## T10/07-312r0 SAS-2 Zoning route table entries for subtractive ports

To: T10 Technical Committee  
From: Tim Symons, PMC-Sierra (Tim\_Symons@pmc-sierra.com)  
Date: 4 July 2007  
Subject: 07-312r0 SAS-2 Zoning route table entries for subtractive ports

Figure 56 — Zoning expander route table

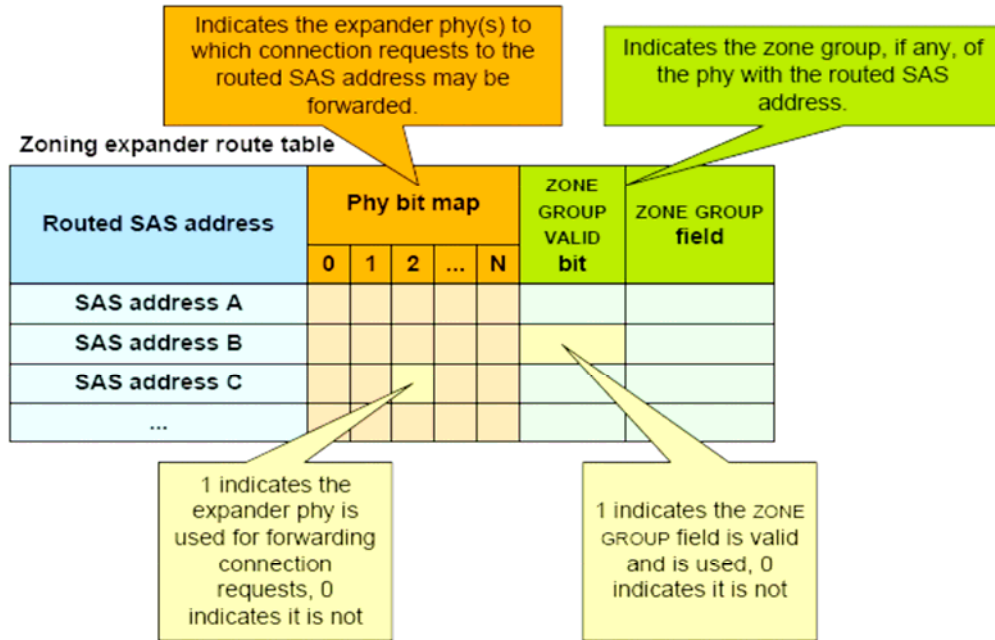
A zoning expander route table is an expander-based expander route table (see 4.6.7.3) that is able to hold the zone group of ~~each~~ routed SAS addresses.

- 1) shall include discovered SAS addresses for all phys with the ROUTING ATTRIBUTE field set to 2h (i.e., table).
- 2) should include discovered SAS addresses for all phys with the ROUTING ATTRIBUTE field set to 1h (i.e., subtractive).

If the number of routed SAS addresses exceeds the value indicated in the MAXIMUM NUMBER OF ROUTED SAS ADDRESSES field then the zone route table should include SAS addresses for phys with the ROUTING ATTRIBUTE field set to 1h (i.e., subtractive) until the total number of routed SAS addresses in the zone route table is equal to the value indicated in the MAXIMUM NUMBER OF ROUTED SAS ADDRESSES field. The order for determining which routed SAS address for phys with the ROUTING ATTRIBUTE field set to 1h (i.e., subtractive) is vendor unique.
